Southwest LRT (METRO Green Line Extension) Project

Supplemental Draft EIS Comments

Comments from Agencies and Other Public Entities

July 2015

2.2 Issue: Access, flow

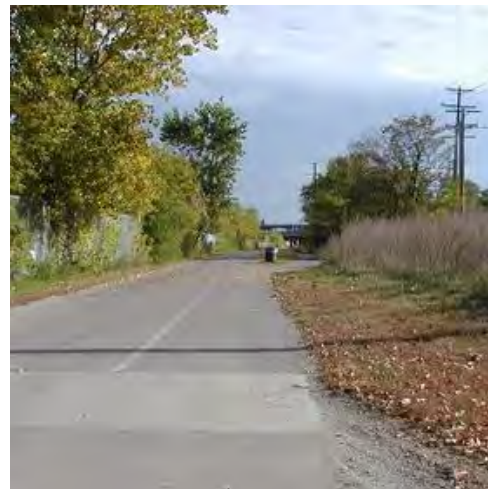
The MPRB is concerned that all future work in this area be based on a comprehensive design and coordinated approach. This location requires formal and safe trail access, and cyclists need continuous flow and speed on the federally funded Cedar Lake Regional Trail.

- 2.2.1 **Outcome:** Trail users easily and safely access the Cedar Lake Regional Trail.
- 2.2.2 **Outcome:** Bicyclists in this area maintain continuous flow and speed.
- 2.2.3 **Outcome:** Trail development is coordinated with rail, residential and commercial development in the area.
- 2.2.4 **Outcome:** The federally funded, nonmotorized Cedar Lake Regional Trail is fully functional, with uninterrupted flow and speed.

Below Grade

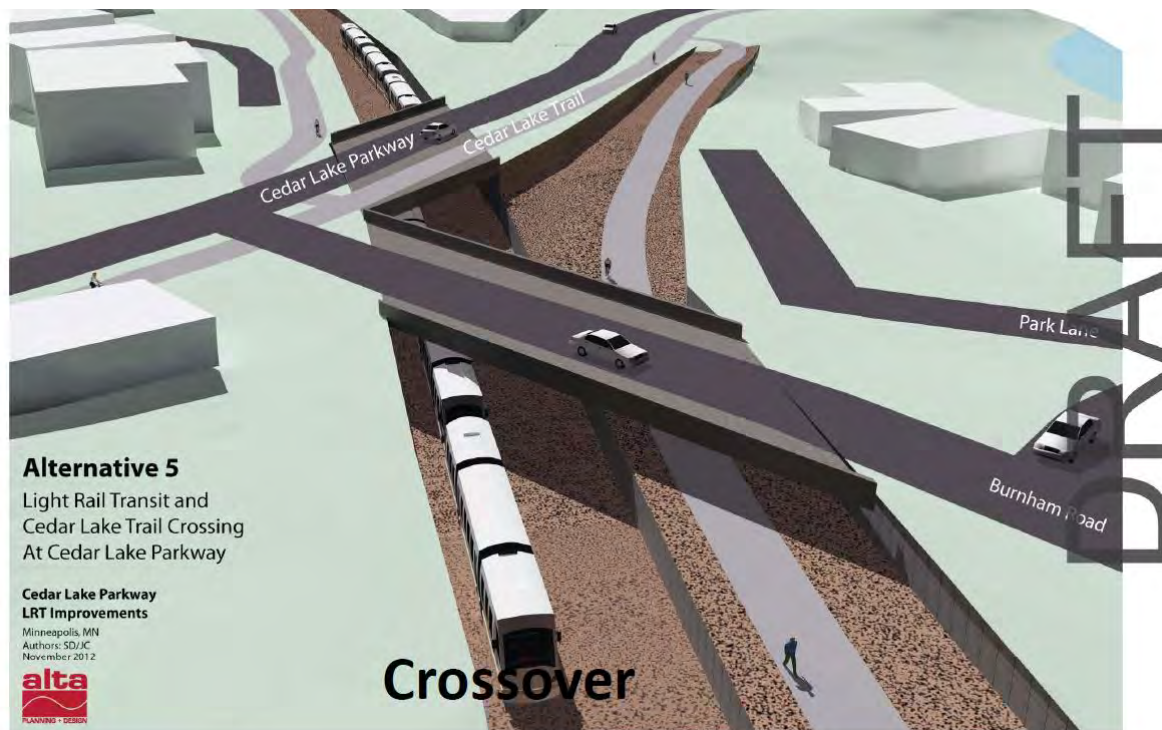
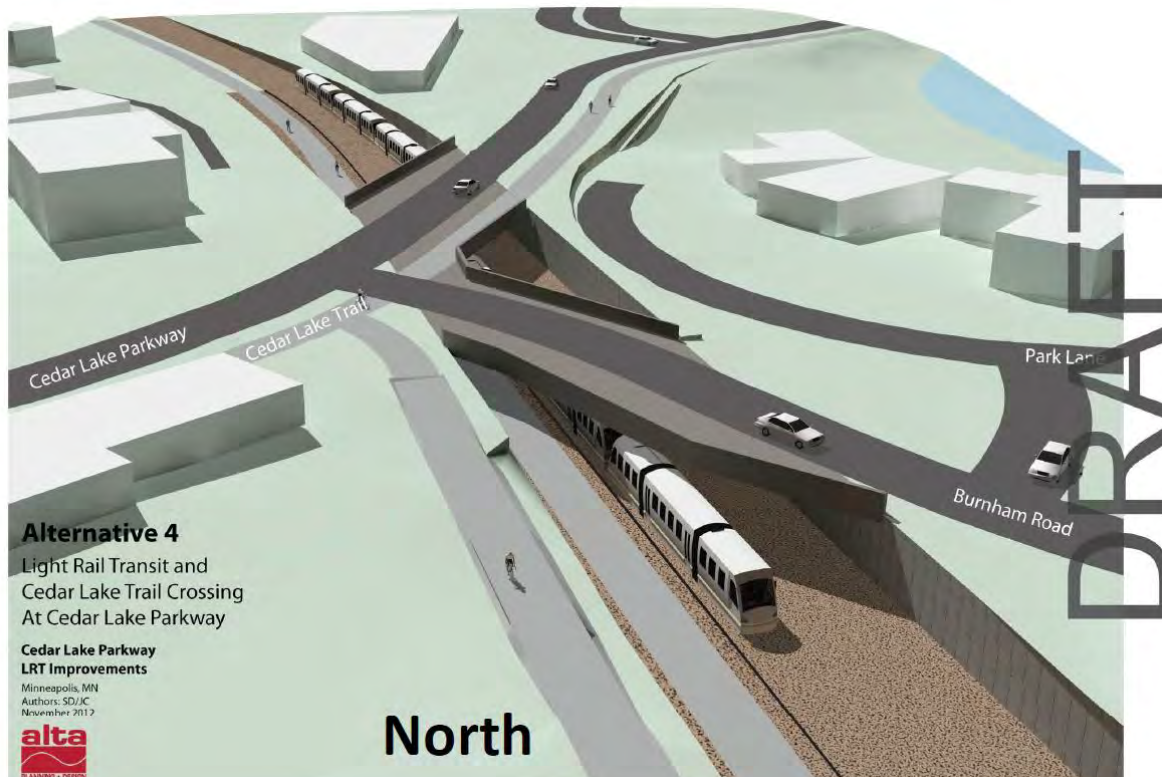
Appendix A is intended to illustrate the concept of lowering the train and trail and bridging Cedar Lake Parkway at the Cedar Lake Parkway/Southwest Transitway intersection. This concept is discussed in Section 9 of this comment letter. The following pages contain a few key images of the analysis conducted on this concept by Steve Durrant of Alta Planning + Design for the MPRB.

Above is a potential cross-section showing elevations for Cedar Lake Parkway (above) and the trail and train.

These are examples of grade separated crossings with trail on east (North version) or west (Crossover version) side of tracks. These are provided to illustrate the concept, not to provide a complete overview of the feasibility study.
